UNITED STATES PATENT AND TRADEMARK OFFICE

APPLICATION NO.	FILING DATE	FIRST NAMED INVENTOR	ATTORNEY DOCKET NO.	CONFIRMATION NO.
10/644,902	08/21/2003	Cheng-Ming Yih	4425-315	6430

Advisory Action

10/644,902

FIG. 2C

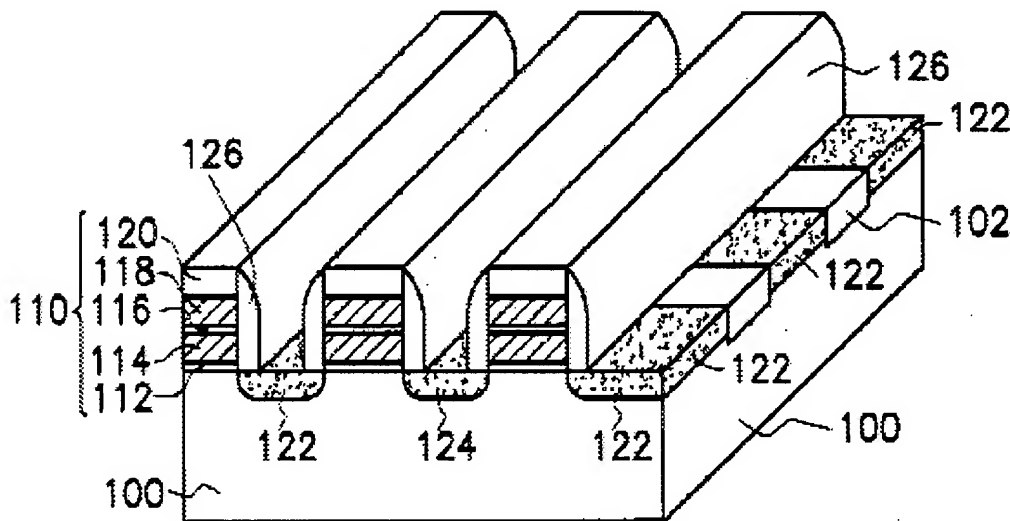
(2) In re the Lee reference, Applicant correctly argued that Lee's "[E]ach source array has a plurality of source regions 124 separately positioned between device isolation lines 102".

Therefore, if Lee's source region 124 is equivalent to the claimed buried **conductive region** (240), which is the case, and if Lee's device isolation lines 102 are equivalent to the claimed isolation regions (210), which is also the case, then Lee's buried conductive region 124 is separately positioned between device isolation regions 102, or in other words, a buried conductive region (124) between said plurality of isolation regions (102).

As for the argument that the depth of the source region can not be visually compared with that of the isolation region, since the depth of the source region (124) can be visually compared with that of the drain region (122, which as clearly depicted from Fig. 2C has a depth similar to that of source region 124 – reinforced by the general knowledge in the art that a source region and a drain region of a nonvolatile memory device have the same depth, which is the case of the Lee's reference, unless specifically formed differently, which is not the case with the Lee's reference) and since the depth of the drain region can be visually compared with that of the isolation region, the depth of the source region can be visually compared with that of the isolation region.
